Product Change Notification (PCN)

Note: While responding, please retain "**PCN Notification:510583**" in the e-mail Subject line for faster response.

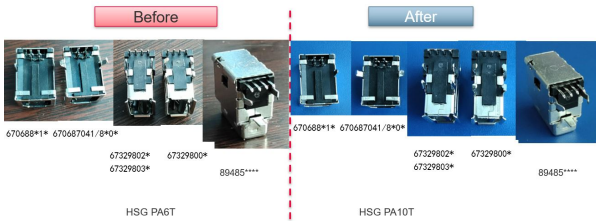
- Due to the resin PA6T global shortage, In order to avoid production line shutdown, We plan to add new resin option PA10T, The surface status as below picture

- Due to the resin PA6T global shortage, In order to avoid production line shutdown, We plan to add new resin option PA10T, The reason of choosing PA10T as below:
 - After the technical parameters compared of PA6T and PA10T, the properties of plastic materials of PA10T is enough to replace and meet the functional application of USB series;
 - The appearance and performance will not be affected for use PA10T.

- Product Impact**
It has no impact to fit, and function
